SERVICE BULLETIN

APPLICABILITY: 2019-21MY Forester

NUMBER: 12-225-21

SUBJECT: Loose Fitting A-Pillar – Design Change

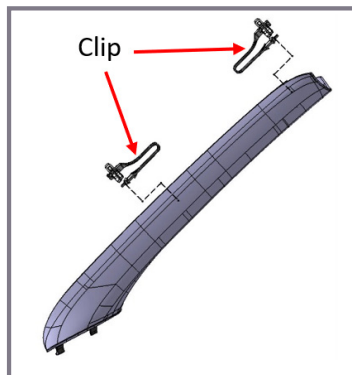
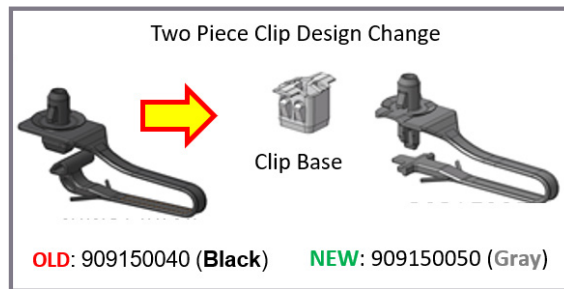
This bulletin announces the design changes made to the A-pillar trim panels and their associated retaining (tether) clips. The trim panel has been enhanced to work in conjunction with a new two-piece retaining clip. These changes were introduced to address some concerns of the A-pillar trim panel coming loose. If this concern is experienced, replace the trim panel(s) along with the associated retaining clip(s).

These changes were introduced into production starting with VIN **MH519540**.
